Guildford Borough Council - Planning Department

Re: 24/P/01734 - The Bungalow, Clay Lane, Guildford, GU4

Worplesdon Parish Council believes that the principle of developing a house at this location (with access off Clay Lane) is unacceptable for a number of planning policy reasons:

Looking towards Woking Road (photograph taken from Google Maps):

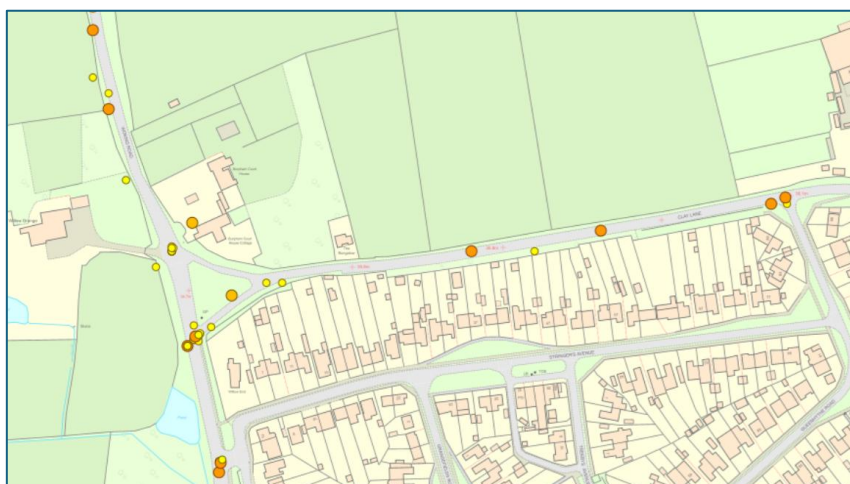
- Clay Lane is a known accident location and has a 40mph speed limit. No visibility splays have been provided, nor has a safety audit. Visibility from 2.4m back from the edge of the highway [to leave the site] will be significantly impeded by vegetation and the existing fencing.

The existing access gates to the site are not set back far enough from the road to facilitate safe access for a vehicle off Clay Lane.

For vehicles exiting the site onto Clay Lane the visibility is seriously compromised. Vehicles regularly exceed the 40mph speed limit, despite the traffic calming measures located closer towards the Blanchard's Hill/Jacobs Well Road/Clay Lane junction (within the 30mph limit).

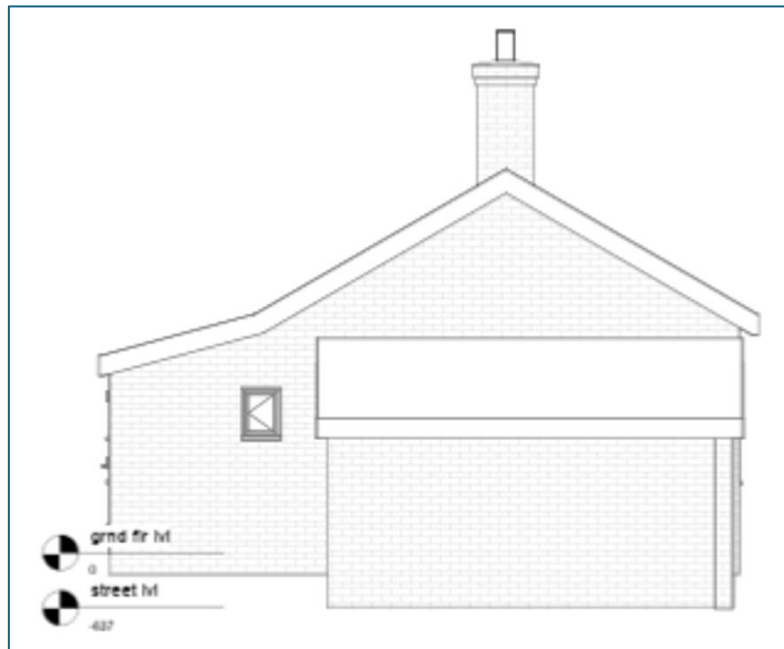
- The Parish Council requests clarification on the orientation of the proposed enlarged structure on the site.

The Climate Change, Energy and Sustainable Development Questionnaire Question 2b refers to additional windows to provide additional light, however the majority of additional glazing appears to be on the rear of the property, which, if that is to be the aspect facing away from Clay Lane, will be north facing – so additional light gain would be minimal. The applicant has omitted to note key points relating to the suggested installation of solar panels (orientation of roof and suggested location on roof, potential for tree canopy to affect solar generation, etc).

The current submitted plans for the existing structure depicts brickwork:

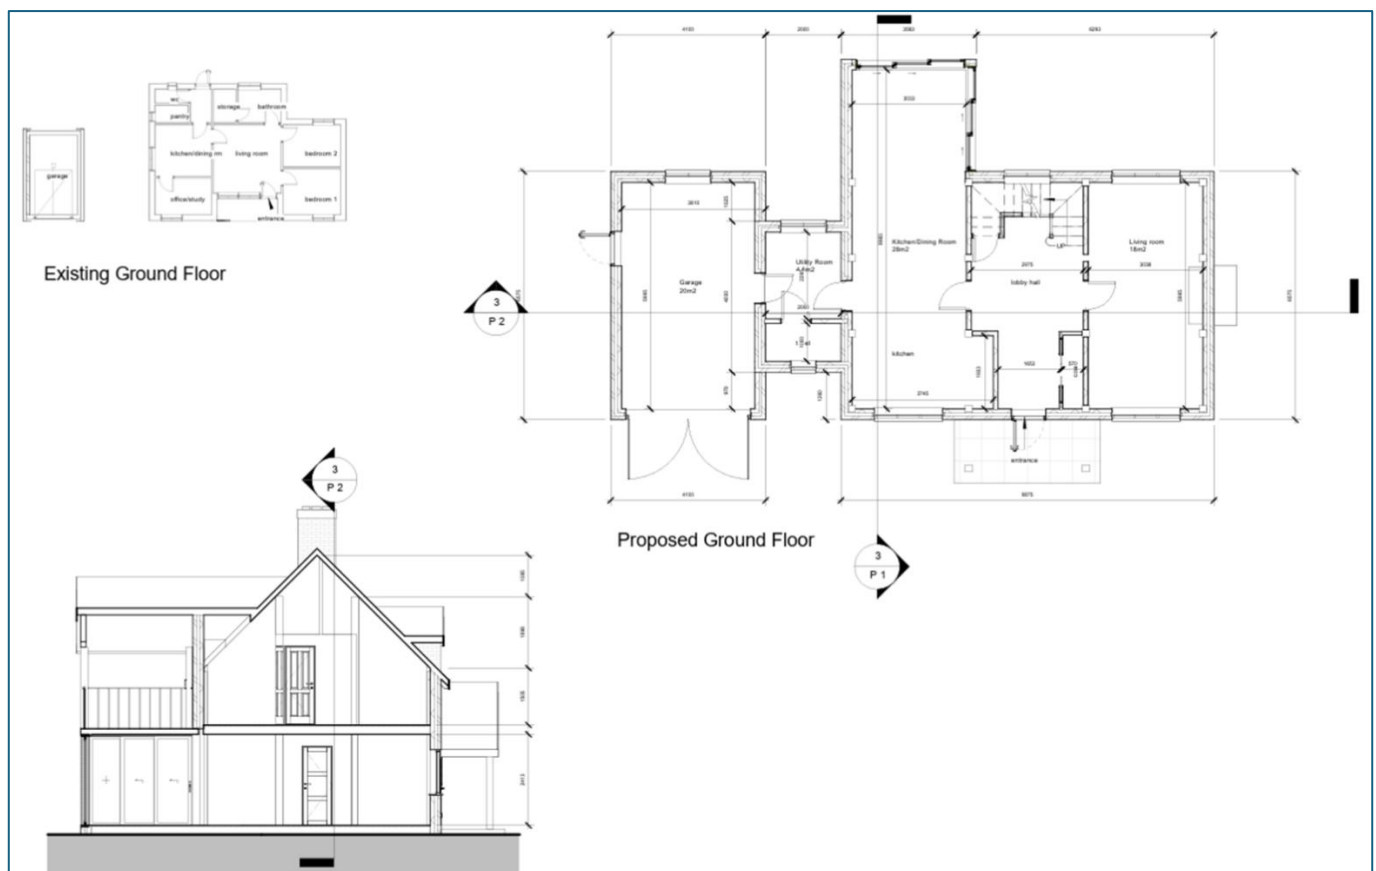
- Previously submitted plans on historic applications show ‘The Bungalow’ as a timber clad structure:

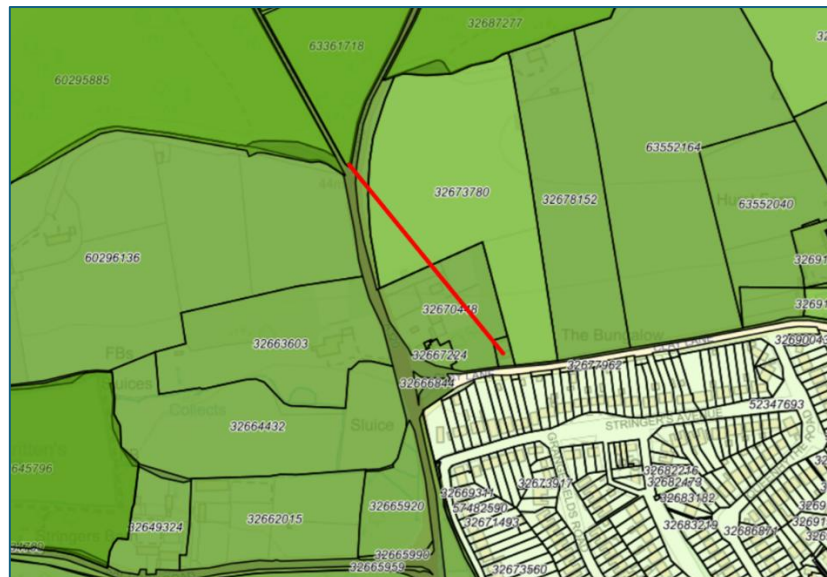
- The site is less than 250m from Whitmoor Common (SPA, SSSI, LNR, BOA):
